U.S. Department  
of Transportation  
**Federal Highway  
Administration**

Refer to: HSA-1\HSA-B78

In your September 5 letter to Mr. Dwight Horne, former Director of our Office of Highway Safety Infrastructure, you requested formal acceptance of a National Cooperative Highway Research Program (NCHRP) Report 350 test level 3 (TL-3) transition design to the Alaska Multi-State Bridge Rail. A test level 4 (TL-4) transition has previously been accepted for use with this bridge rail. To support your request, you also sent copies of the August 2000 report prepared by the Texas Transportation Institute, "NCHRP Report 350 Test 3-20 of the Alaska Multi-State W-Beam Transition" and the July 2000 report, "NCHRP Report 350 Test 3-21 of the Alaska Multi-State Bridge Rail W-Beam Transition," plus video tapes showing the two tests that were conducted.

Figure 1. Details of the Alaska Multi-State W-Beam Transition.

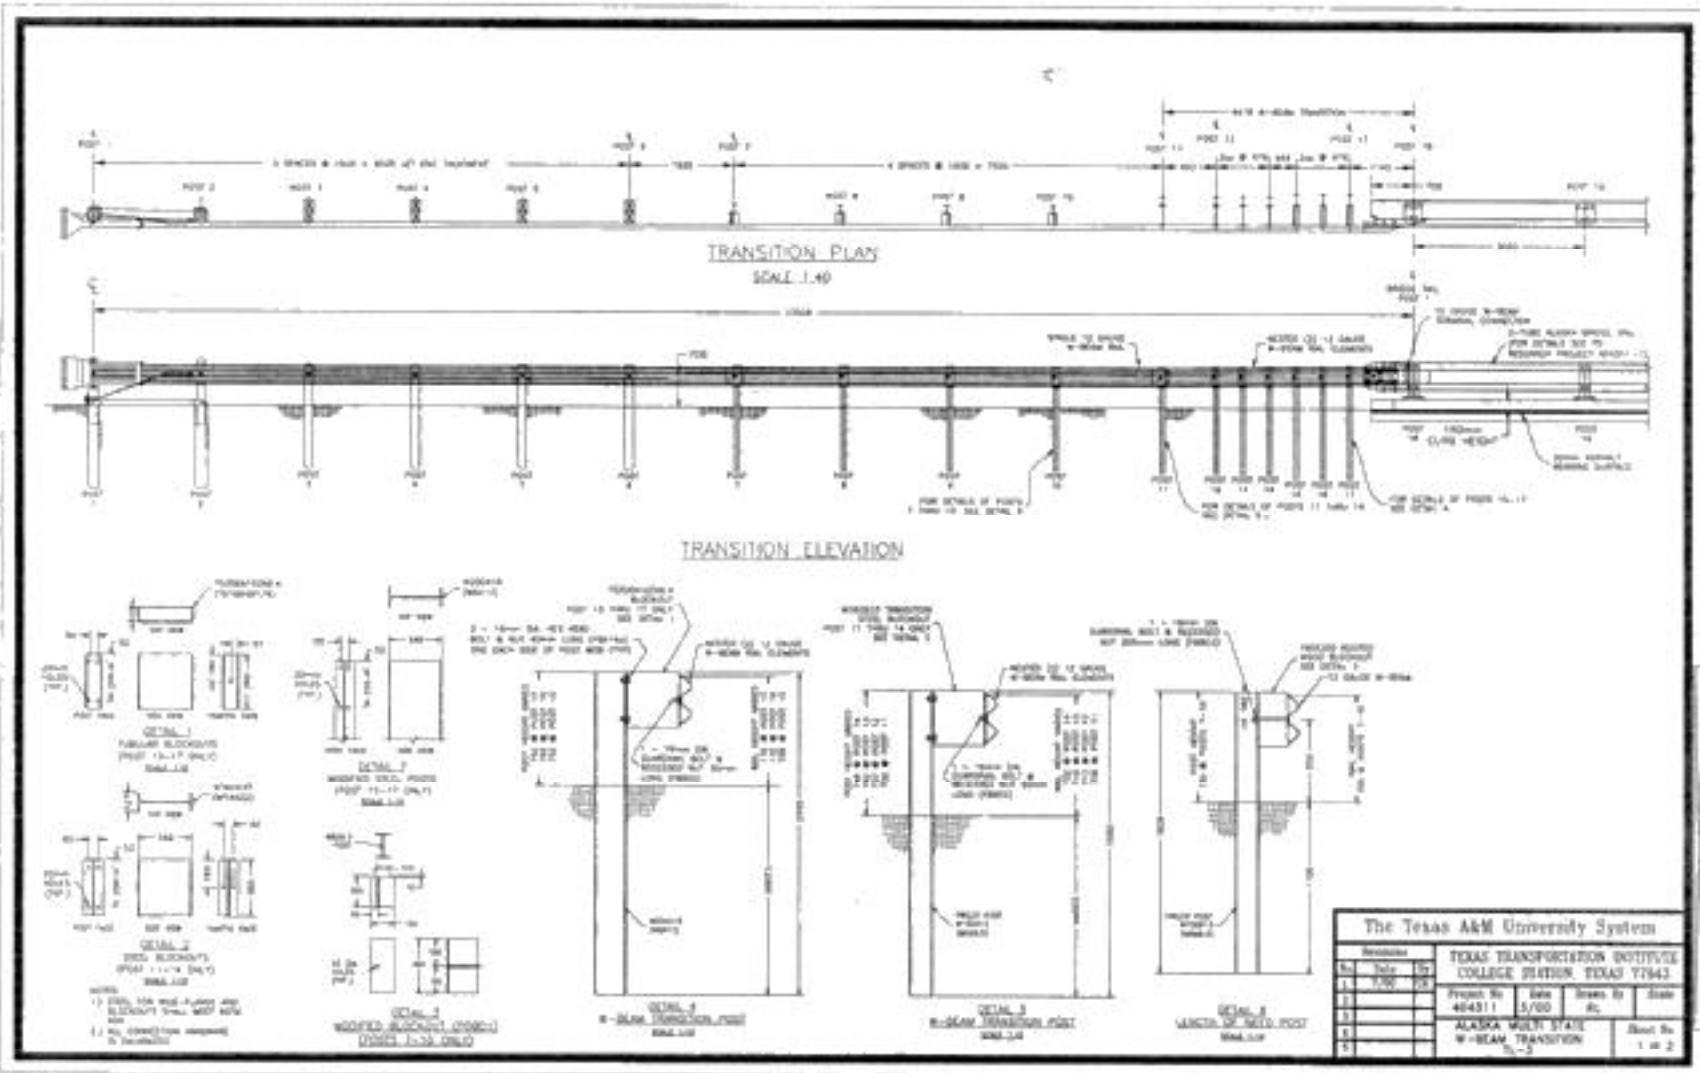
As shown in detail in Enclosure 1, the transition consists of two nested 12-gage W-beam panels connected to the Alaska Two-Rail Bridge Rail with a standard W-beam terminal connector and a fabricated steel connection plate. The connection plate was designed to permit use of either the W-beam or Thrie-beam transition without having to modify the bridge rail. Posts 15 through 17 are W200 x 19 x 2090-mm long, each having blockouts 360-mm high fabricated from TS 356 x 102 steel. Post 17, immediately adjacent to the bridge, is offset 1145 mm from the first bridge rail post. Posts 11 through 14 are W150 x 13.5 x 1980-mm long and have W360 x 33 steel blocks. Post embedment depths, shown in Enclosure 1, vary to match the approach rail to the Alaska Bridge rail. The concrete curb was flared back 114-mm over its last 457 mm to minimize wheel snagging at that point.

Review of the test reports and video tapes confirm that the Alaska W-beam transition meets the NCHRP Report 350 evaluation criteria for TL-3 performance. Summary sheets for the two tests that were conducted are shown in Enclosure 2. However, there was significant vehicle contact near the first bridge rail post in both tests. This resulted in 170-mm of intrusion in the driver's side kick panel of the 820-kg car and a considerable amount of damage to the bridge deck during the pickup truck impact. As a result of this performance, you stated that this design will be used

primarily on roads with low traffic volumes and design speeds. It may be possible to improve the design significantly by extending the curb beyond the end of the bridge deck, thereby minimizing vehicular snagging and damage to the structure at this location. It appears that the wheels of both test vehicles folded under the slightly-raised W-beam and contributed heavily to both vehicular and structural damage. An approach curb, leading away from the bridge and tapered under the transition, would likely minimize the extent of this intrusion.

Based on staff review of the test reports and the video tapes, I concur that the TL-3 Alaska W-beam transition design, as tested, may be used in conjunction with your Multi-State Bridge Rail on the National Highway System when such use is requested by a transportation agency. I understand that the design, like the bridge rail, is non-proprietary and that copies of detailed plans and specifications can be obtained directly from you upon request.
